**Site Address: 617 SANTA YNEZ WY SAC**  
Parcel No: 004-0274-024

**Nature of Work: 696 SF 2ND STORY ADDITION**

CAMMACK/MERJAVICH RESID.  
ADDENDUM TO STRUCT. CALCS.

RE: Cammack/Mekjavich Residence, 617 Santa Ynez Way, City of Sacramento;  
Permit #0008883R

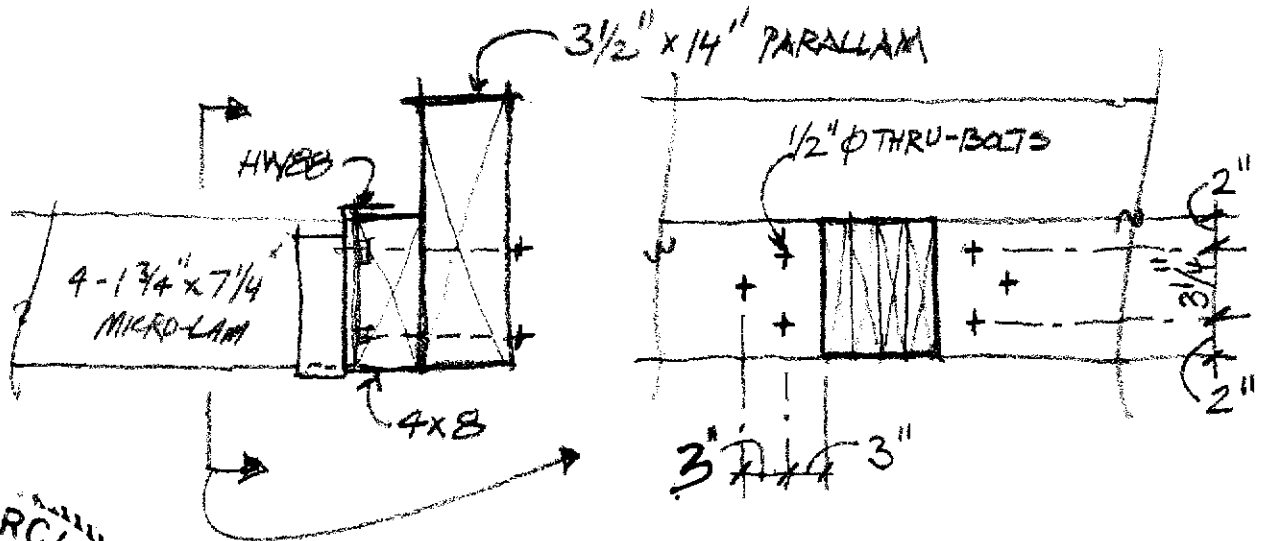
LOAD TO 4-1 3/4" x 7 1/4" MICRO LAM BEAM

ROOF:  $(12/2)(30) = 180 \#/l$

FLOOR:  $= 51 \#/l$

WALL:  $(6)(10.0) = 60 \#/l$

W TOTAL  $\frac{291 \text{ STAT}}{300 \#/l}$

$V = (15/2)(300) = 2250 \#$

USE HWES  
HANGER

CONDITION C 14" DEEP BEAM 1

USE 4x8 LEDGER TO BEAM w/ 3- 1/2"  $\phi$   
THRU-BOLTS EA. SIDE OF 4-1 3/4" x 7 1/4" BM

APPENDUM TO STRUCT. CALCS.

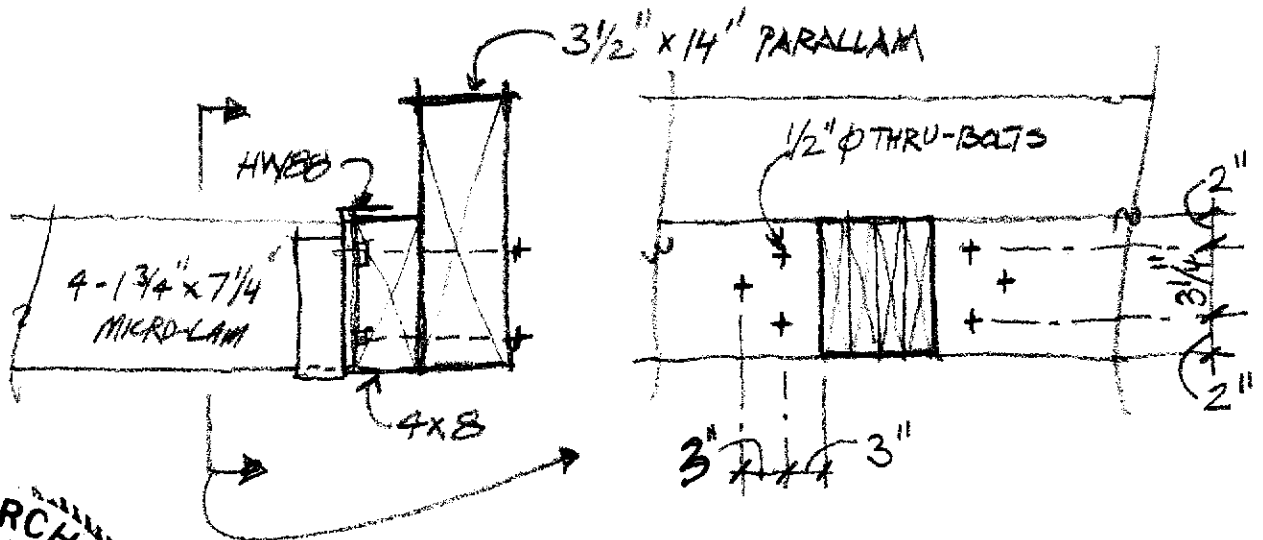
LOAD TO 4-1 3/4" x 7/4" MICRO LAM BEAM

ROOF:  $(12/2)(30) = 180 \#/\prime$

FLOOR:  $= 51 \#/\prime$

WALL:  $(6)(10.0) = 60 \#/\prime$

W<sub>TOTAL</sub> =  $\frac{291 \text{ SAY } 300 \#/\prime}{}$

$V = (5/2)(300) = 2250 \#$

USE HWES  
HANGER

CONDITION C 14" DEEP BEAM:

USE 4x8 LEDGER TO BEAM w/ 3-1/2"  $\phi$   
THRU-BOLTS EA. SIDE OF 4-1 3/4" x 7/4" BM
